AMENDMENT OF SOLICITATION/MODIFICATION OF CONTRACT			1. CONTRACT ID CODE	PAGE 1 OF 2 PAGES
2. AMENDMENT/MODIFICATION NO. AMENDMENT NO. 0002		3. EFFECTIVE DATE 04/04/14	4. REQUISITION/PURCHASE REQ. NO.	5. PROJECT NO. (If applicable) 12-0088
6. ISSUED BY CODE		CODE mks	7. ADMINISTERED BY (If other than Item 6) CODE See Item 6	
Officer in Charge of Construction MCI-East 1005 Michael Road Camp Lejeune, NC 28547-2521				
8. NAME AND ADDRESS OF CONTRACTOR (No., street, county, State and ZIP Code)			(X)	9A. AMENDMENT OF SOLICITATION NO. N40085-12-R-0088
			X	9B. DATED (SEE ITEM 11) 03/25/14
				10A. MODIFICATION OF CONTRACT/ORDER NO.
				10B. DATED (SEE ITEM 11)
CODE	FACILITY CODE

12-0088 Repair Electronic Maintenance Shop, Building HP104

N40085-12-R-0088

Amendment 0002

DUCT TAKE-OFF DETAIL

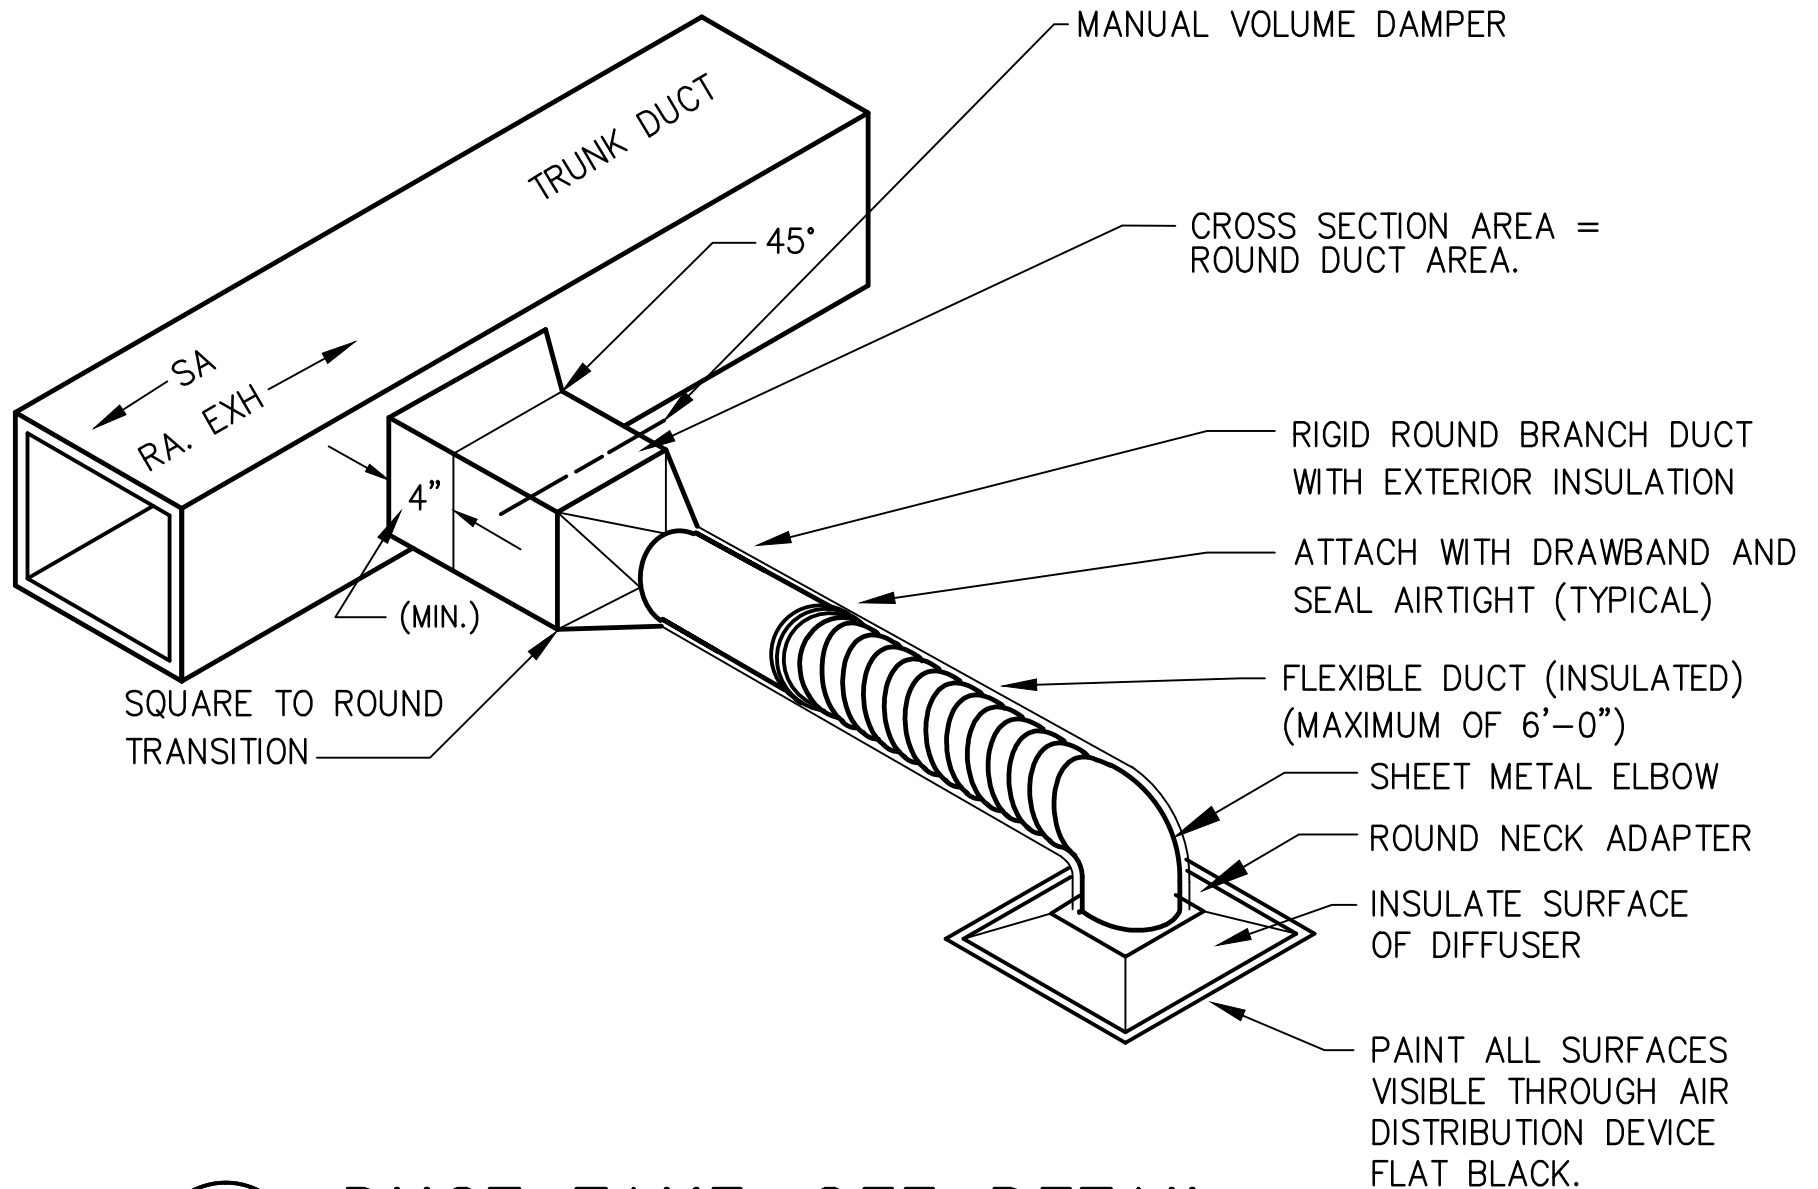
2. M-4 detail for duct take-offs mentions 45 degree and conical. All duct take-offs shall be 45 degree with a manual balancing damper in these applications. See attached detail.
